Work Order ID 129205

Item Name: Fwd Crosstube - High 407

D407-667-145

DRAWING NO. D407-667-145	TITLE CROSSTUBE ASS'Y (407 HIGH FWD)	REV. C	DART AEROSPACE LTD ENGINEERING ORDER		D.E.O. NO. D407-667-145-C-1	SHEET NO. SHEET 1 OF 1	SCALE NTS
DRAWN 90	CHECKED 155	MFG. APPR. 155	APPROVED 155		DE APPR. 155		
DATE 11.07.15	DATE 11.07.22	DATE 11.07.22	DATE 11/07/22		DATE 11.07.21

DETAIL P
BONDING STRAP INSTALLATION 2 PL

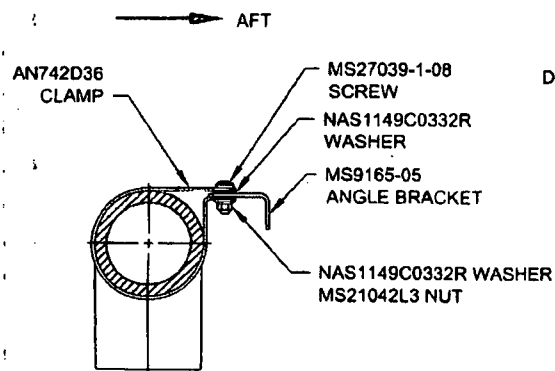
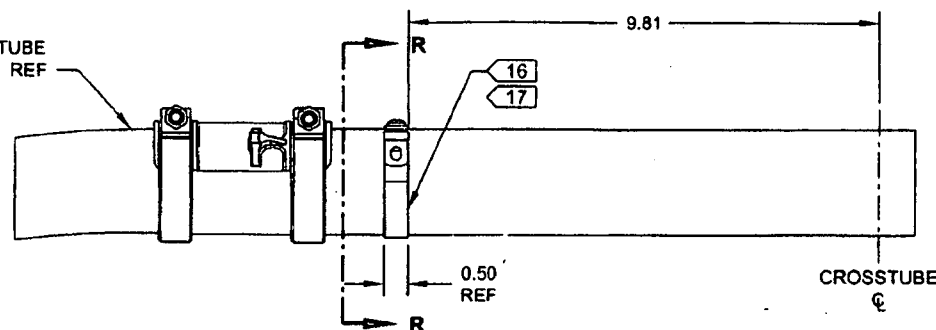
ADD ELECTRICAL GROUNDING STRAP

ADD
